METROPOLITAN GOVERNMENT OF NASHVILLE AND DAVIDSON COUNTY

STAFF RECOMMENDATION
1419 Holly Street
May 16, 2012

Application: Infill, Demolition and Setback Reduction
District: Lockeland Springs-East End Neighborhood Conservation Zoning Overlay
Council District: 06
Map and Parcel Number: 08309042800
Applicant: John Root
Project Lead: Robin Zeigler, robin.zeigler@nashville.gov

Description of Project: The proposed project is to demolish an existing non-contributing building at the rear of a corner lot at Holly and North 15th Streets and to construct two single-family residences with one oriented towards Holly Street and one oriented towards North 15th Street.

A1 ARCHITECTURAL SITE PLAN
SCALE: 1/16"=1'-0"

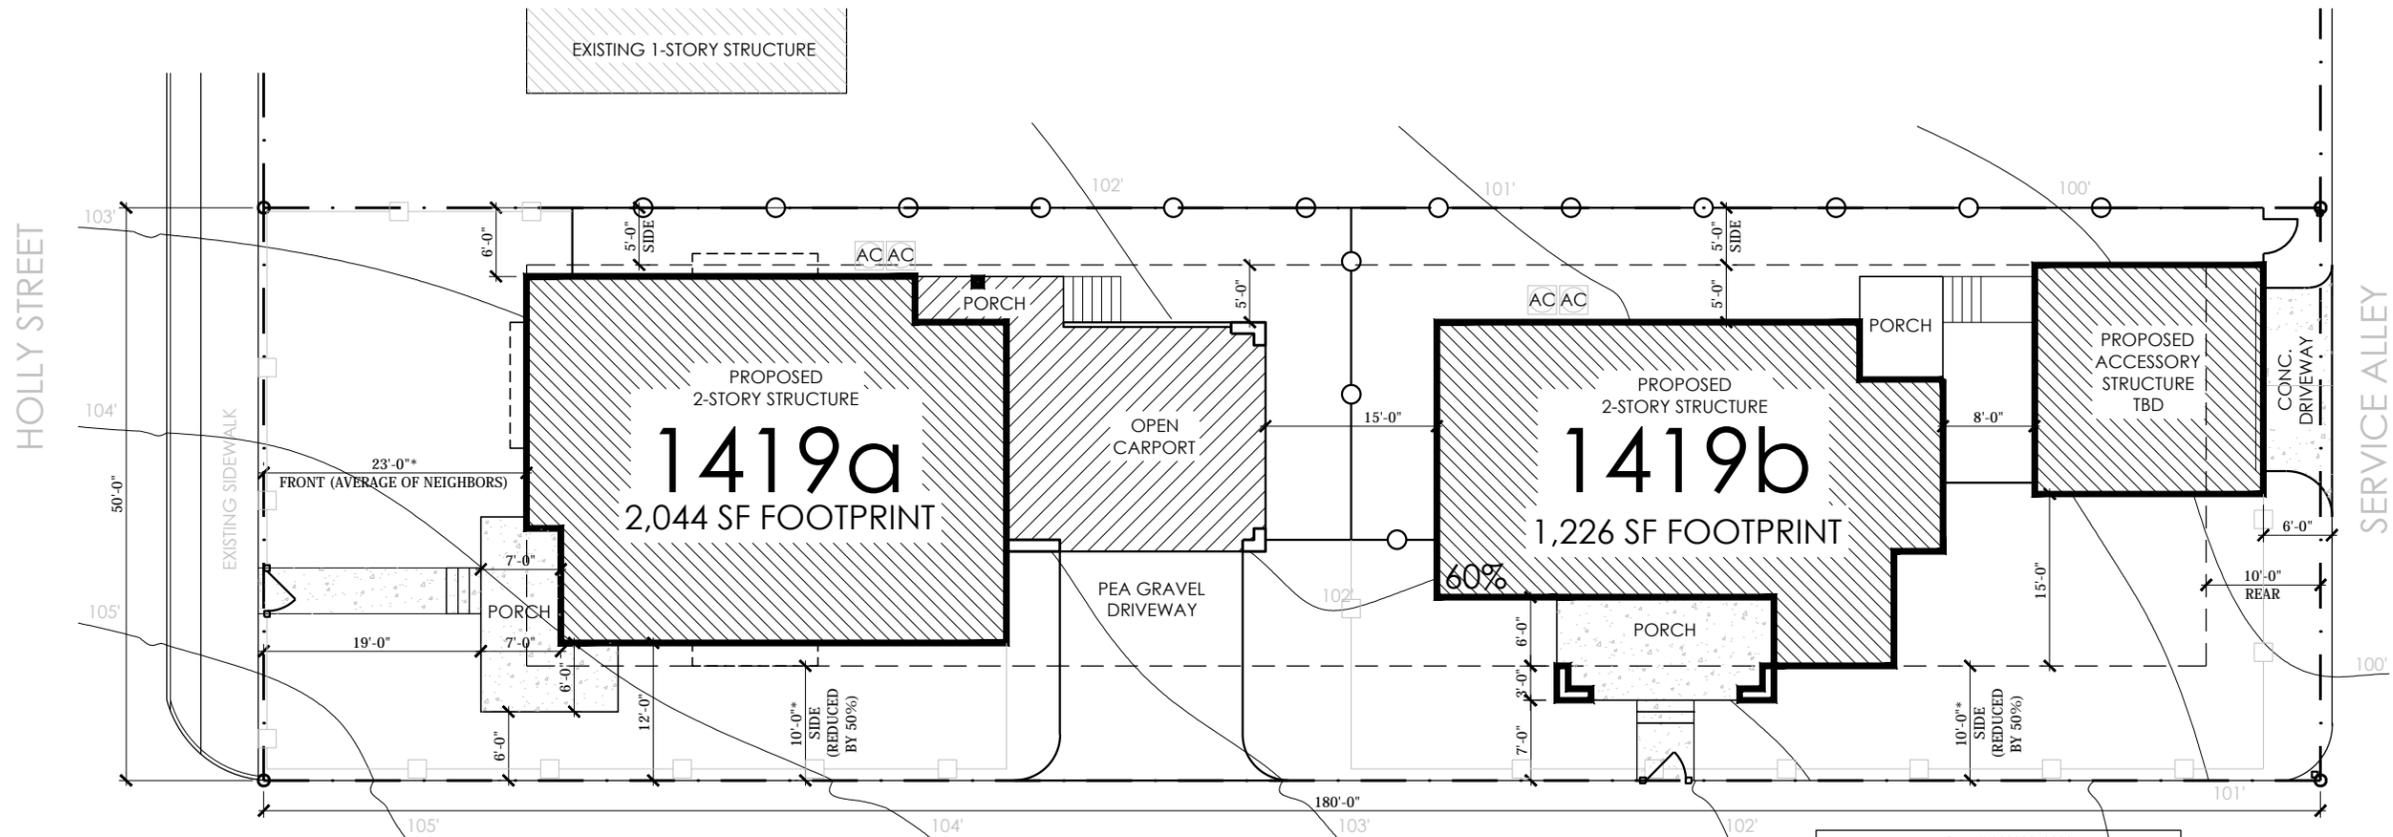
The policy for corner detached duplexes requires that the secondary building be located in the rear 30% of the lot. The applicant is permitted to have one accessory structure and two are proposed. If the approval allows for a carport attached to the primary building, the secondary unit should be moved closer to the alley to be approximately located in the 30% region allowed; however, if the approval requires the removal of the carport and allows the rear garage to remain, the secondary unit is in the appropriate location.

Vehicular access for the project is with a driveway leading from the alley to a two-car garage and a double-wide (16') driveway leading from North 15th Avenue to a two-bay carport with conditioned space above. Typically, the commission has not allowed for street-facing garages, attached garages at any location other than a basement level, and new curb cuts. In addition, the policy for corner detached duplexes is to have both units accessed from the alley, where one exists, and only one garage or carport. This project proposes both a garage and a carport as well as an additional curb cut.

Since the two homes will now appear to be separate lots, staff suggests amending the policy to allow for an additional curb cut for a primary unit, when an alley exists, to allow for access to the secondary unit. Staff suggests that the curb cut be narrowed to one lane; however, that may not be feasible since vehicles from this parking area would need to back out; therefore, staff recommends a new design for the driveway that incorporates a product such as turf-pavers and concrete strips to minimize the impact of the width. With these conditions, the project meets section II.B.6.

However, the proposed carport is located at the center of the lot and attached to the house. The proposed is more than a simple carport with four posts and a roof, as this carport has substantial corners, potentially allowing for garage doors to be installed at a later date, and a second-story conditioned space. In addition, the policy for corner detached duplexes only allows for one carport or garage for the entire lot, not for each building. Staff recommends removal of the middle carport from the design and the addition of a concrete parking pad and windows to the exposed north elevation. With these conditions, the project meets section II.B.8.

1. Staff provide final review of windows and doors
2. The carport attached to the primary building be removed and windows be added to the north side of the building.
3. Existing driveway be redesigned to either be one lane of concrete strips or appear to be one lane by using a product such as turf-pavers.
